## RECALL Replace Non-Compliant A-Pillar Trim

No: RB176  
Ref:  
Issue: 1  
Date: 06 December 2004

Freelander (LN)

## Part Numbers and Warranty Claims Processing - Recall B176

Figure 1

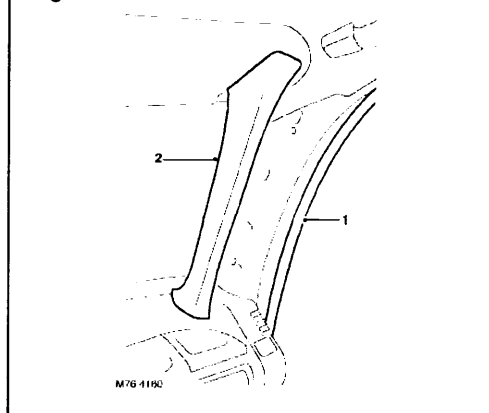
Tests completed during a Conformity of Production assessment on behalf of the NHTSA have revealed that Freelander vehicle A-pillar trim may not fully meet the stated requirement for the Head Impact Criteria aspect of Federal Motor Vehicle Safety Standard (FMVSS) 201.

1. Refer to GTR section 76.13.26 and remove both left hand and right hand A-pillar trim. (Figure 1)

Vehicles within the affected VIN range are to have the A-pillar trim replaced with a revised component that enables the vehicle to fully meet the requirements of FMVSS 201.
